Office Action Summary

DETAILED ACTION

2. The text of those sections of Title 35, U.S. Code not included in this action can be found in a prior Office action.
3. **Claims 1-3, 6-7 and 11 are rejected under 35 U.S.C. 102(e) as being anticipated by Inagaki (US 6,765,246) (hereinafter Inagaki).**

FIG. 1

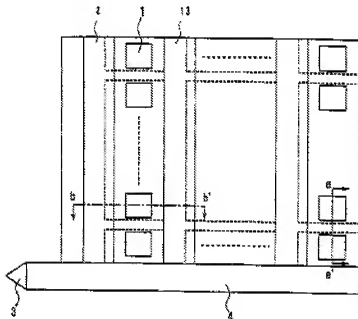
With respect to claim 1, Inagaki (c.g. Figures 1-3; reproduced above) teaches a solid state image pickup device comprising:

- a semiconductor region 7 on a substrate 5 (Figures 2 and 3), *said semiconductor region having an upper and lower face;*
- a plurality of photo-sensors 1 on the *upper face of the* semiconductor region (column 5, lines 42-44; column 6, lines 2-4 and 20-25);
- a transfer register 2 *which extends in a vertical direction and is located in the* semiconductor region *and* which transfers (column 6, lines 5-9) signal charges accumulated in said photo-sensors (column 5, lines 49-51);
- an impurity region 13 (horizontal gridlines between adjacent photodiodes in vertical direction) *which extends* across substantially the *entirety* of the semiconductor region from one end of the semiconductor region to an opposite end of the semiconductor region in a direction orthogonal to the transfer (vertical) direction of said transfer register (column 6, lines 39-52); *and*

- *a channel stop region 12 which is separate from said impurity region and has a higher impurity concentration than that of the impurity region 13* (column 7, lines 38-41 and 48-51), wherein
- said impurity region 13 is provided between *those of* said photo-sensors 1 *which are* adjacent to each other along the transfer direction of said transfer register in the semiconductor region (column 6, lines 42-46), *and*
- *said channel stop region 12 is located between said photo-sensors 1 adjacent to each other along the transfer direction of said transfer register in the vicinity of the surface of said semiconductor region* (column 6, lines 34-38)

With respect to claim 2, Inagaki (e.g. Figures 2 and 3) teaches that said impurity region 13 is *located closer to the lower face of* the semiconductor region than said transfer register (vertical CCD) (column 6, lines 2-4 and lines 39-42).

With respect to claim 6, Inagaki (e.g. Figures 3 and 6) teaches that in addition to said impurity region portion 13, a first barrier region portion 15 comprised of an impurity region between said photo-sensors (photodiodes) adjacent to each other in the transfer direction of said transfer register and *closer to the upper face of the semiconductor substrate than* said impurity region portion (column 6, lines 46-49).

With respect to claim 7, Inagaki (e.g. Figure 1) teaches a second barrier layer 13 (vertical gridlines between adjacent photodiodes in horizontal direction) (column 6, lines 39-52) comprised of an impurity region portion along said transfer register.

Inagaki (e.g. Figures 2 and 3) further teaches an overflow barrier 6 between the semiconductor layer and the substrate.
